Subject: Fwd: Email 1 of 3 BOS File No. 200800, 3516 and 3526 Folsom Street

Re: Appeal of CEQA Revised Mitigated Negative Declaration for 3516 and 3526 Folsom Street dated 4/24/2020

December 1, 2016

Figure 4: PG&E transmission line relative to proposed site plan.

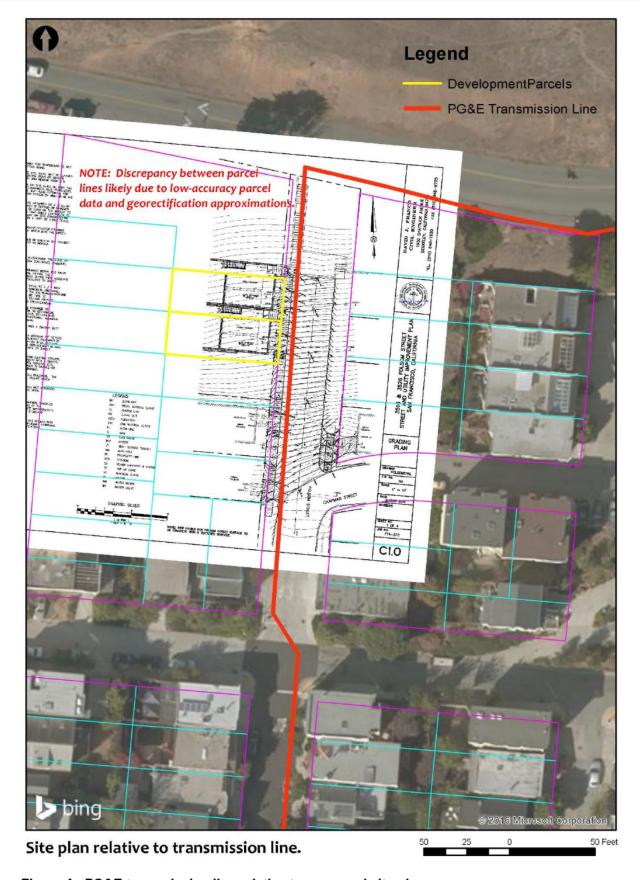
The proposed projects are located immediately adjacent to a major PG&E transmission natural gas pipeline (Figure 1, Figure 2, Figure 3). This major pipeline is located immediately below the primary access road for the construction (Figure 4, Figure 5), immediately adjacent to significant proposed new utility work (e.g. gas service, water supply, sewer) as well as removal of existing pipeline soil cover (Figure 6, Figure 7), and immediately adjacent to significant proposed bedrock excavation (depths on the order of 6 to 10 feet per the submitted architectural elevations (such as sheet A-3), as seen in .
